**IN THE MATTER OF: Notice of Requirement for
the Designation of Pinehaven Stream (UHC-92).**

STATEMENT OF EVIDENCE

James Gary Beban

Figure 4-4 Hydrological catchments

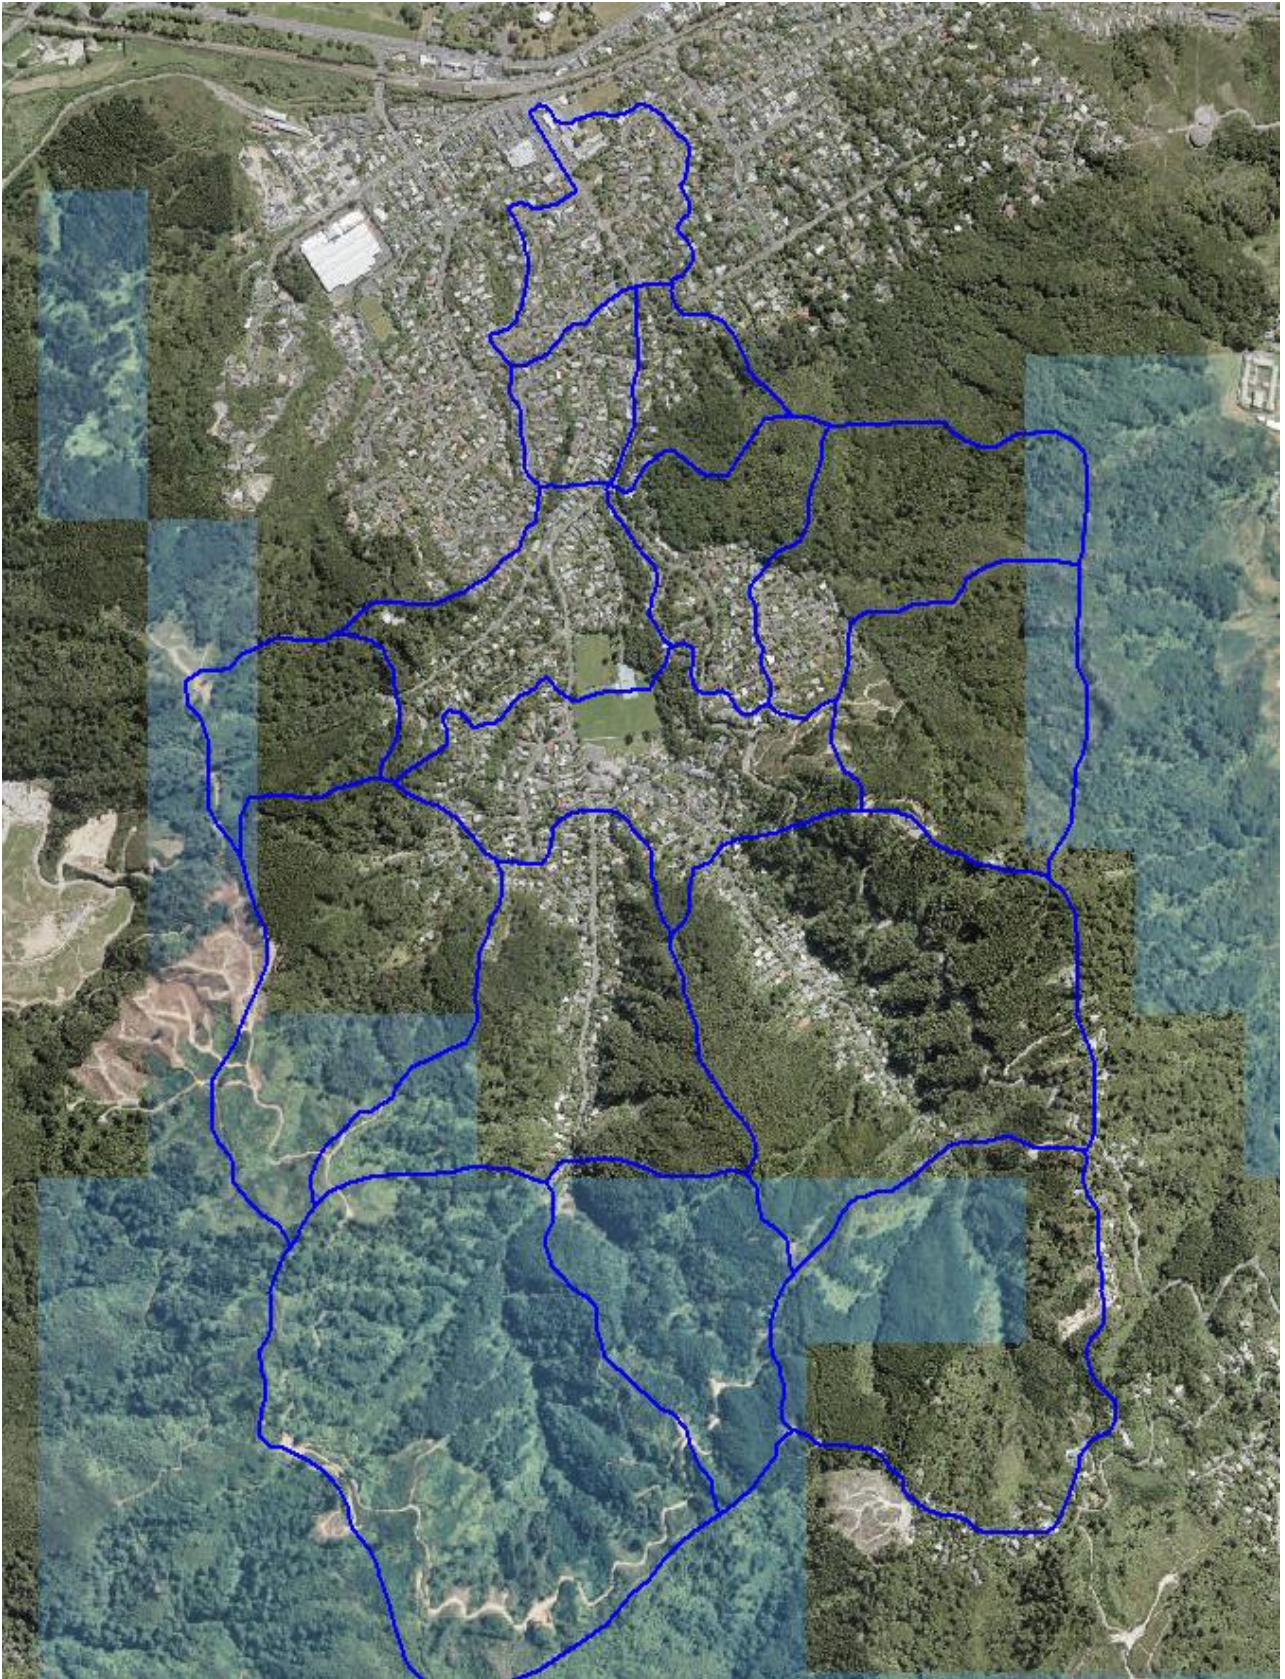
<p>Catchments</p>	<p>Figure 4-4 shows the catchments used in the hydrological modelling. The catchments range from 0.735km² to 0.1397km². Catchments of this size are large for a detailed design model, but given the lack of detail in the hydraulic model (e.g. no stormwater pipe network) these are appropriate. Based on the 2D surface supplied with the model they appear to be delineated appropriately.</p>	<p>Findings and comments on catchment size acknowledged. Agreement with appropriateness of catchment size and delineation, based on resolution and detail of base model.</p>	<p>CLOSED</p>	<p>1</p>	<p>Yes</p>

Figure 4-5 Changes to DEM – Design model on the left and Base model on the right

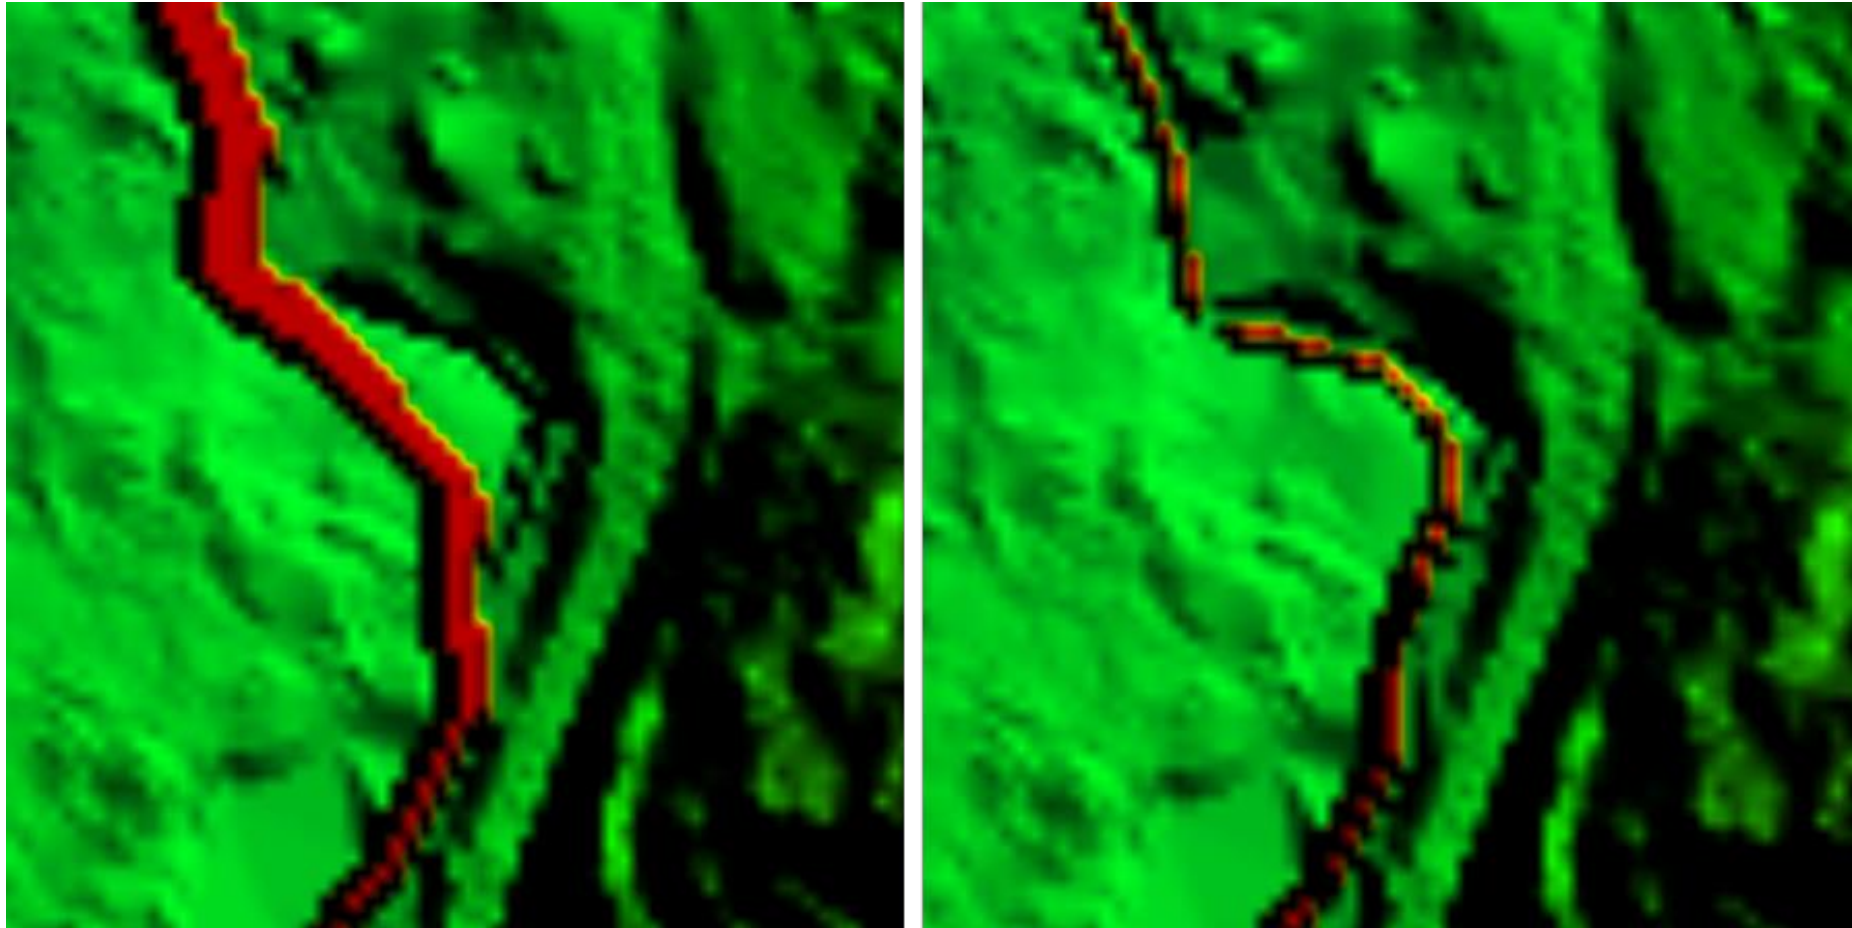
Item Checked	Findings & Comments	Modeller's response	Reviewer close out comments	Rating	Fit for use
MIKE21					
Grid/Mesh	<ul style="list-style-type: none"> Model includes two gridded surfaces; representing Base (pre) and Design (post) proposed stream works Model updated with 2013 LiDAR The model uses a grid of 2x2 m. This is an appropriate level of detail, and more refined than the 5x5 m grid reviewed in 2015. The extent of the grid is such that the flood plain is covered. This is confirmed by the 100-year ARI results showing that that no water is glass-walling at the edges of the grid. The Pinehaven Stream between Pinehaven Reserve and Whitemans Rd has been blocked out of the grid where M11 is present to prevent double counting. The blocking out has been increased in areas of stream widening (this matches changes to the M11 cross-sections) as indicated by the red areas in Figure 4-5. The stream centreline and mesh blockout at 28 Blue Mountains Rd between the Design model and Base model is slightly different. 	Agreement with findings and comments noted.	CLOSED	0	Yes

Figure 4-7 Cross-section 1496 (proposed as per June 2020)

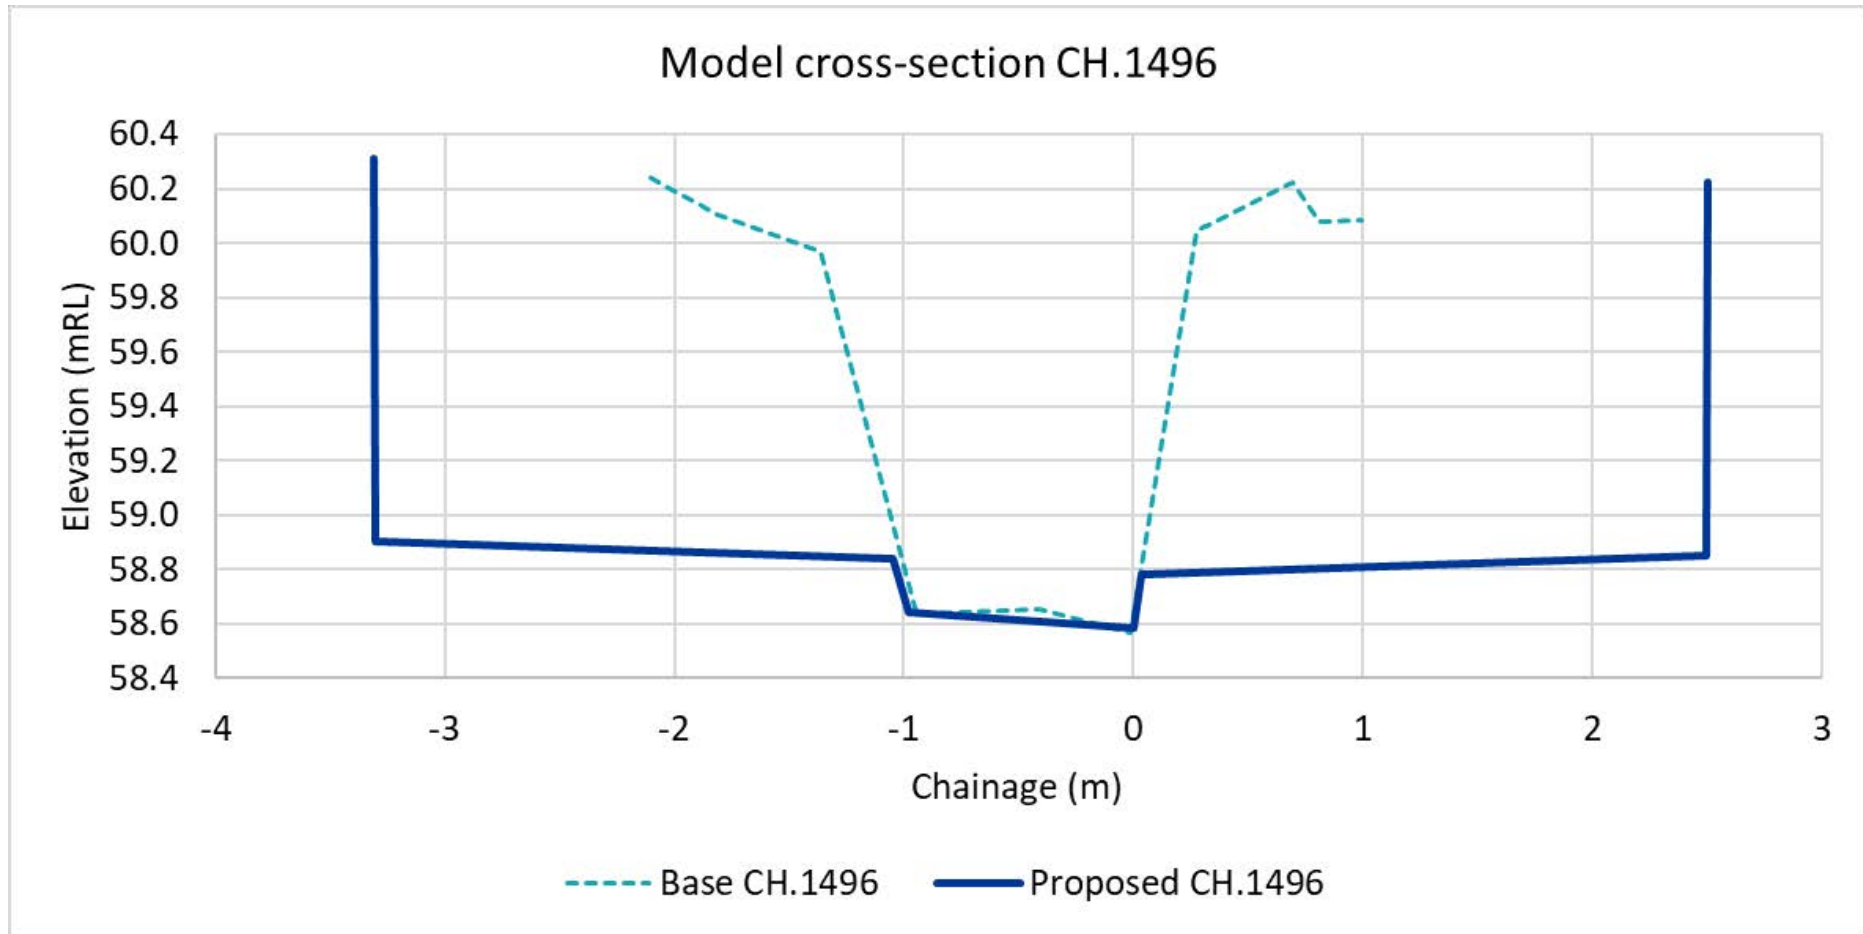
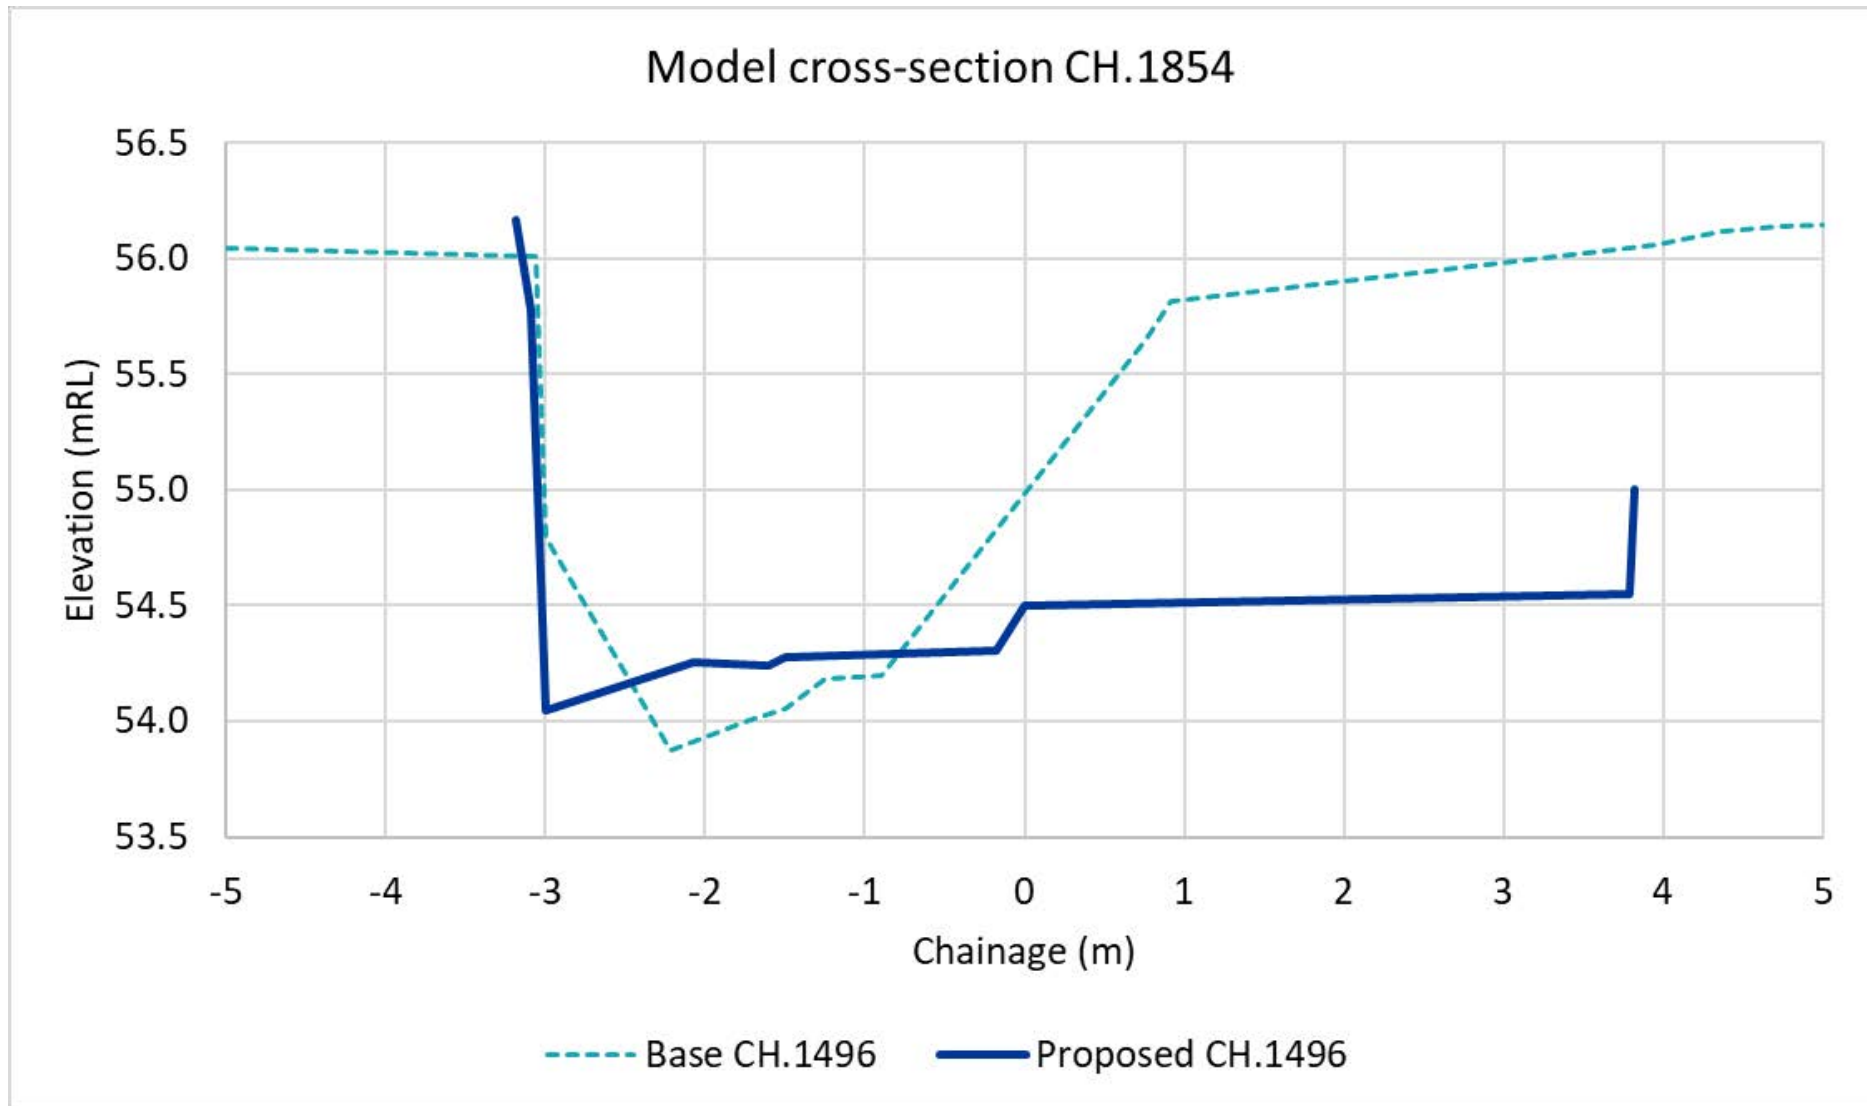
Item Checked	Findings & Comments	Modeller's response	Reviewer close out comments	Rating	Fit for use
Cross-sections	<ul style="list-style-type: none"> Design drawings of the proposed cross-section have not been received and therefore we cannot comment on the representation of these in the model. We are limited to comparing the design cross sections to those in the Base case model. The stream works detailed in the <i>Pinehaven Stream Improvements</i> report appear in model chainages Ch 1488 – 1604 inclusive; and Ch 1838 – 2430 inclusive (2017 12d design). An example is shown in Figure 4-7 for cross-section 1496. The lower ~200mm of channel has been left the same as the Base model representing no modification to this portion of the cross-section The design cross-sections contain vertical walls (approx 1.5m high). <u>Note that if these can't be achieved due to stability etc any changes to the side slopes would need to be re-modelled as it may result in a loss in conveyance.</u> 	<p>Additional survey was collected to update the quantity and resolution of stream cross-sections from what was represented in the preliminary models.</p> <p>Proposed cross-sections included reference to updated survey information where applicable.</p> <p>In vertical cross sections, up to a 2-inch per row of blocks may be integrated into the proposed design.</p> <p>Following completion of final design of the block walls, if a batter is proposed, a check will be performed on all cross sections to confirm that the effective flow area is not decreased (it is noted this may extend top of bank extents by a nominal amount).</p>	<p>We agree with the modeller's response. Checks should be made to the final design cross-sections to confirm that the hydraulic performance meets the performance of the reviewed model.</p> <p>CLOSED</p>	1	Yes

<p>June 202 Update</p> <ul style="list-style-type: none"> There have been some changes to the design cross-sections (see Figure 4-6). We assume these are the final design cross-sections. Results still show flooding to be reduced (in most places) as a result of the design cross-sections (See FHA for more commentary on results). 		<p>CLOSED</p>	1	Yes
